SERVICE BULLETIN

Bulletin Number: SB1202

Subject: EPA vent valve (rollover vent) membrane may become plugged when coming into direct contact with fuel in tank. (Worldlawn and Encore part number 363411.)

Part Number 363411
Vent Valve

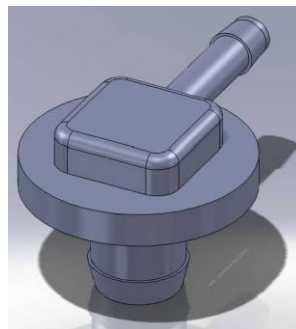
Procedure: The following procedure must be followed to lessen the chance of possible damage to EPA tank assemblies because of vent failure.

- Remove hose from vent barb.
- Either remove vent from tank or perform the following with vent in place.
- Bend a small angle (approx. 1/4"-3/8") on end of .035 welding wire or similar (large paper clip).
- Insert wire into barb end of vent valve until you feel the wire poke through the vent membrane. (Do this three times per vent.) This will provide adequate ventilation.
- Reinstall venting assembly.

Note: Please perform the above vent repair procedure on all vent valves (363411) which you may have in stock. All Worldlawn inventory has been adjusted. Please keep in mind that this procedure is not in any way a violation of EPA System Requirements.
